# Access Compliance Report

## Public Rights-of-Way

Intersection ID: 10276	Main Street: ASHLEY_RD	Cross Street: TUCKASEEGEE_RD	Location: SW
ADA ID: 219BCE20CA62	Ramp Type: Perp	Initial Pass/Fail: Fail	Overall Compliance: No
			Severity Score: 21.25

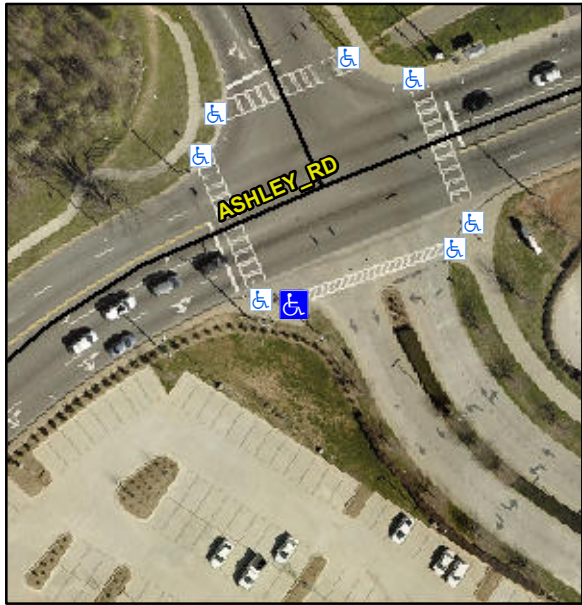
Codes/Mitigation Info/Possible Solution			Field Measurements/Component Compliance					
	Possible Solutions:		Compliance	Description	Data	Compliance	Description	Data
	Remove & Replace Entire Ramp.		N/A	Ramp Length (in)	84.0	No	Ramp Slope (%)	8.4
			No	Ramp Width (in)	47.5	Yes	Ramp XSlope (%)	0.3
			N/A	Flare Type LT	N/A	N/A	Flare Type RT	N/A
			N/A	Flare Slope LT (%)	N/A	N/A	Flare Slope RT (%)	N/A
			N/A	Flare Traversable LT?	N/A	N/A	Flare Traversable RT?	N/A
			N/A	Landing Length (in)	N/A	N/A	DWS Provided?	N/A
			N/A	Landing Width (in)	N/A	N/A	DWS Contrast?	N/A
			N/A	Landing Slope (%)	N/A	N/A	DWS Length (in)	N/A
			N/A	Landing X Slope (%)	N/A	N/A	DWS Full Width?	N/A
Surveyor Notes:			N/A	Landing Curb? (Y/N)	N/A	N/A	DWS Offset (in)	N/A
N/A			N/A	Shared Landing?	N/A			
PROW/ADA:			N/A	Gutter Ponding?	N/A	N/A	Gutter Slope (%)	N/A
R304.5.1, R304.2.2			N/A	Gutter Lip Ht (in)	N/A	N/A	Gutter X Slope (%)	N/A
			N/A	Painted X Walk1?	Yes	N/A	Painted X Walk2?	N/A

X Walk 1 Direction	To E		X Walk 2 Direction	N/A
			N/A	X Walk 1 Width (in)	51.0	N/A	X Walk 2 Width (in)	N/A
				X Walk 1 Slope (%)	1.8		X Walk 2 Slope (%)	N/A
				X Walk 1 X Slope (%)	3.3		X Walk 2 X Slope (%)	N/A
			N/A	Ramp inside XWalk1?	Yes	N/A	Ramp inside XWalk2?	N/A
				Road Slope (%)	N/A	N/A	Clear Space?	N/A
				Road X Slope (%)	N/A	N/A	Clear Space to XWalk (in)	N/A
			N/A	Any Obstructions?	N/A	N/A	Storm Grate/Utility Hazard?	N/A
				Obstruction Type			Storm Grate/Utility Type	
					N/A			N/A
						Yes	Surface Condition? (G/P)	Good
